AGENDA CITY OF CEDAR FALLS, IOWA PLANNING AND ZONING COMMISSION MEETING WEDNESDAY, JULY 24, 2024 5:30 PM AT CITY HALL, 220 CLAY STREET

2. Preliminary Plat – North Cedar Estates (PP23-007)

SUBJECT: North Cedar Estates Preliminary Plat (PP23-007)

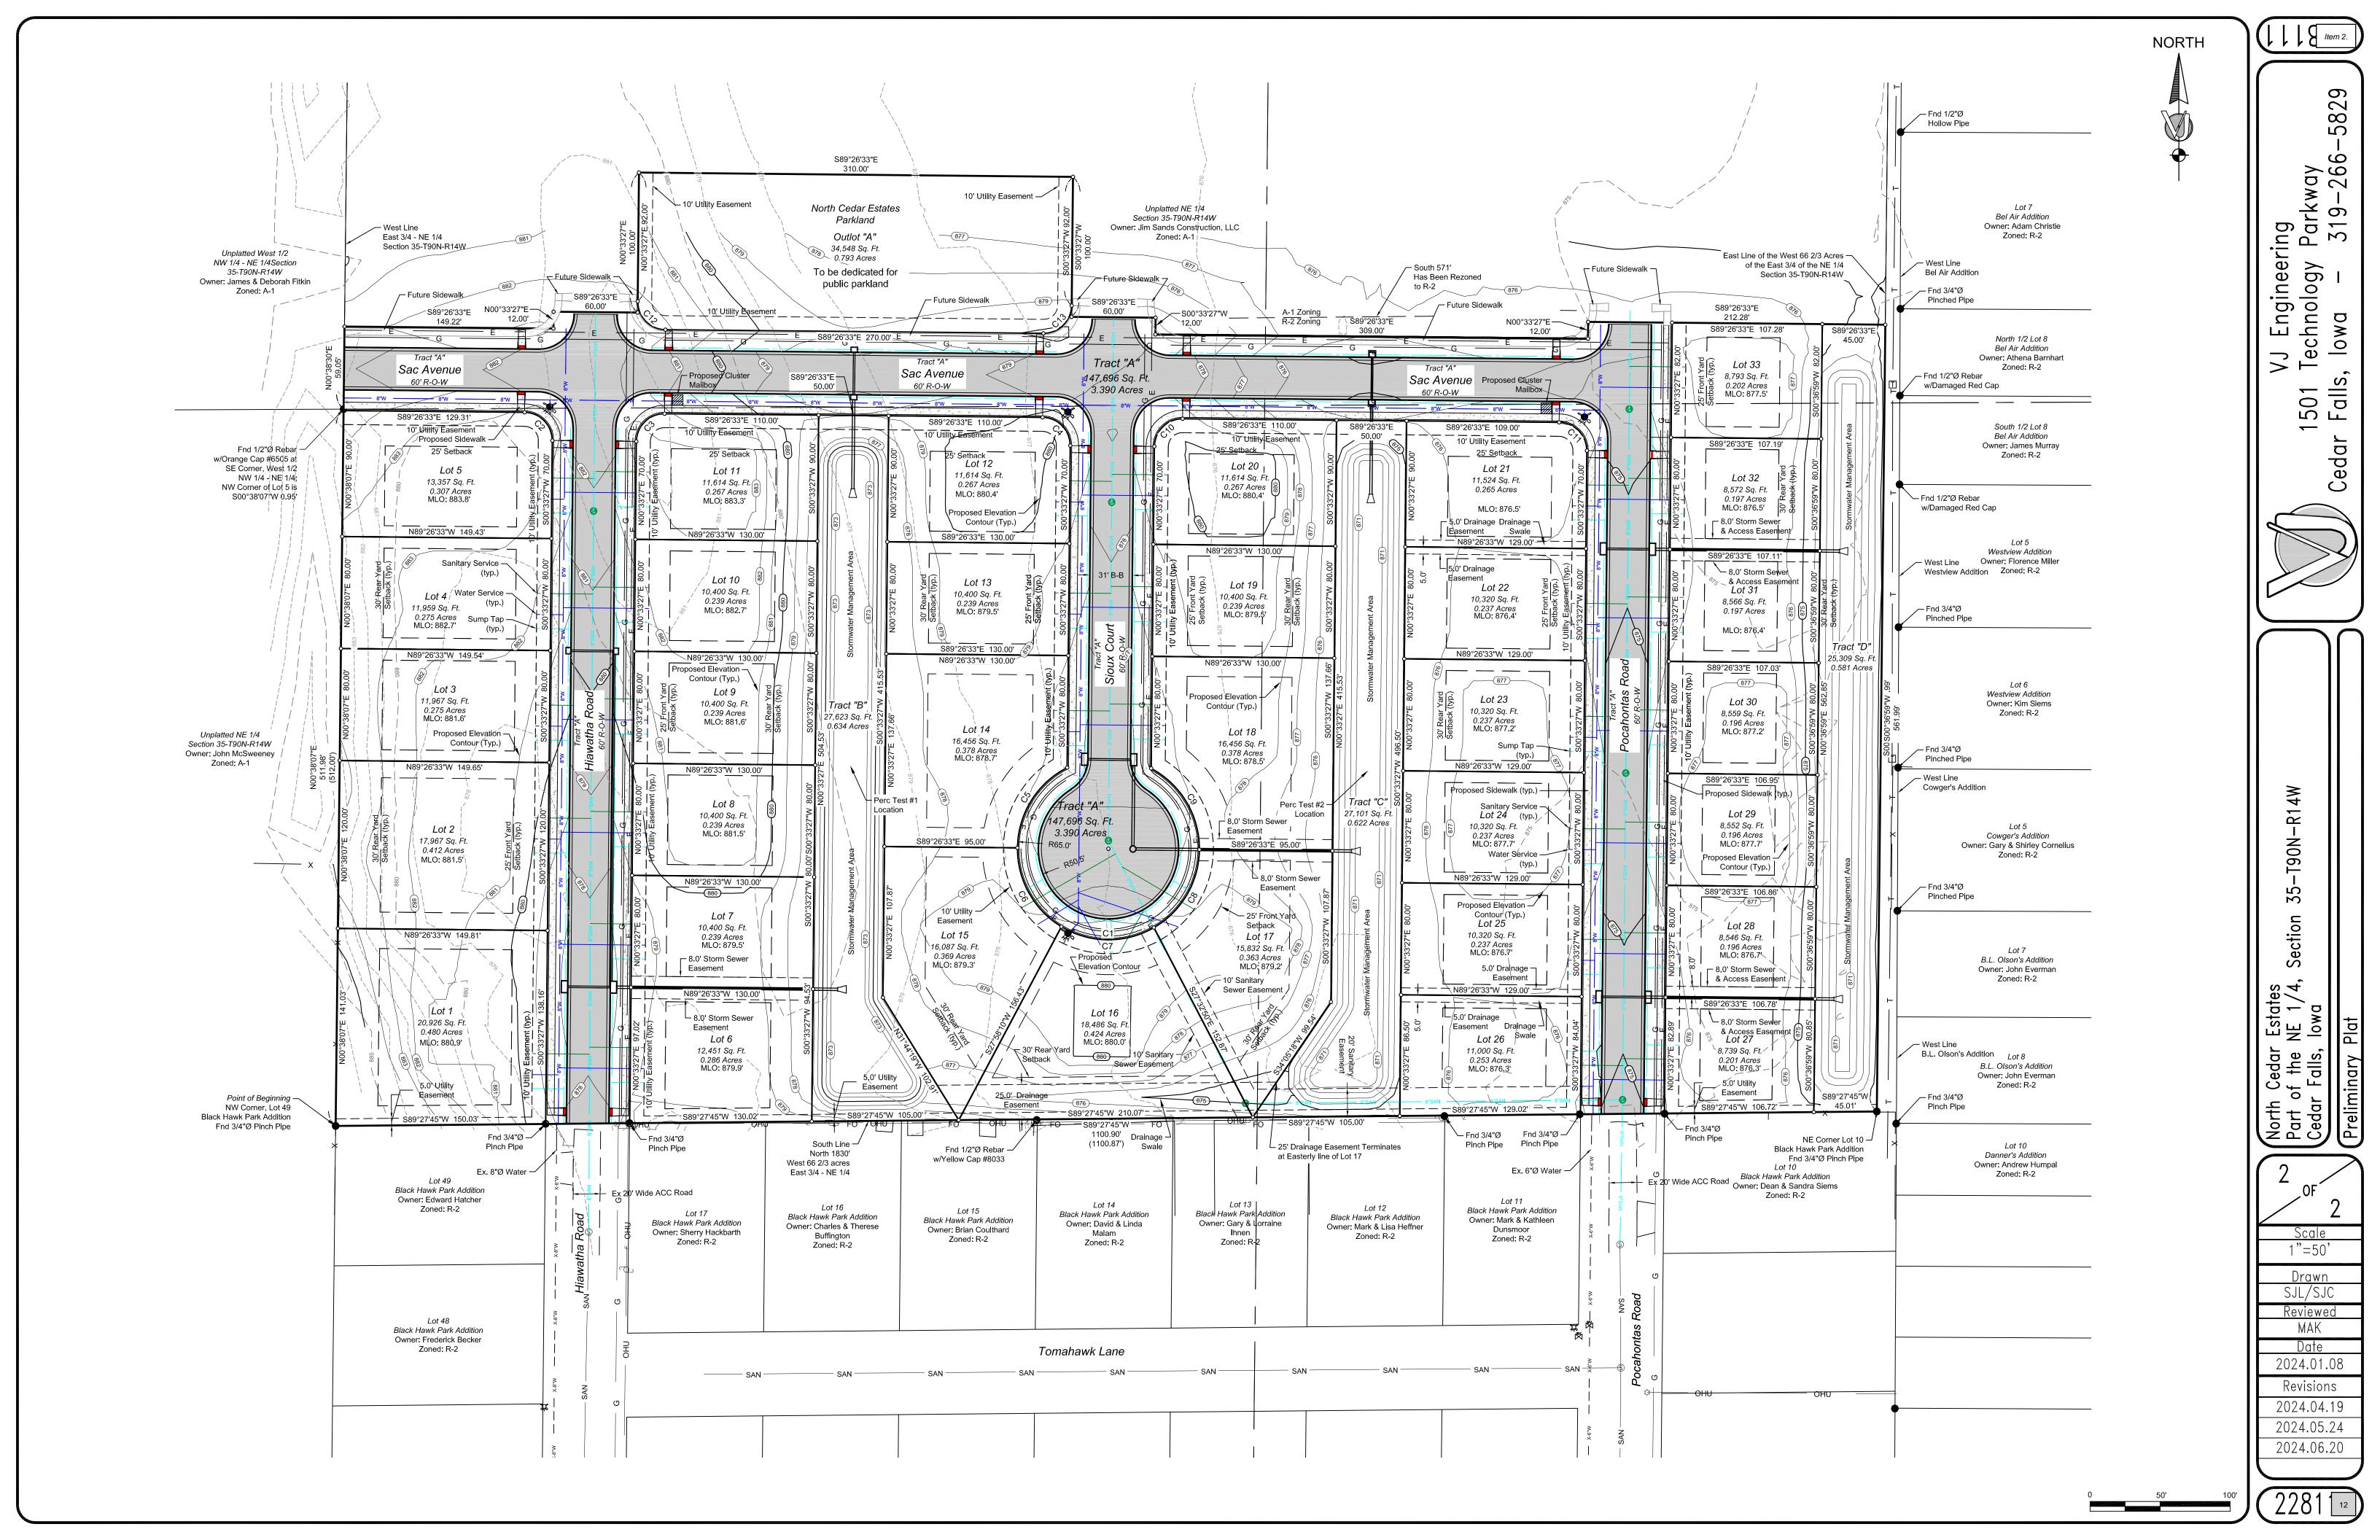
A public sidewalk should be constructed along the frontage of the public park at the time the streets are constructed. The wording on the plat should be changed from "future sidewalk" in this location to illustrating construction with the street.

Amendments to the deed of dedication will be needed to acknowledge and address any conditions associated with the parkland, such as grading and seeding to meet City specifications prior to conveyance to the City.
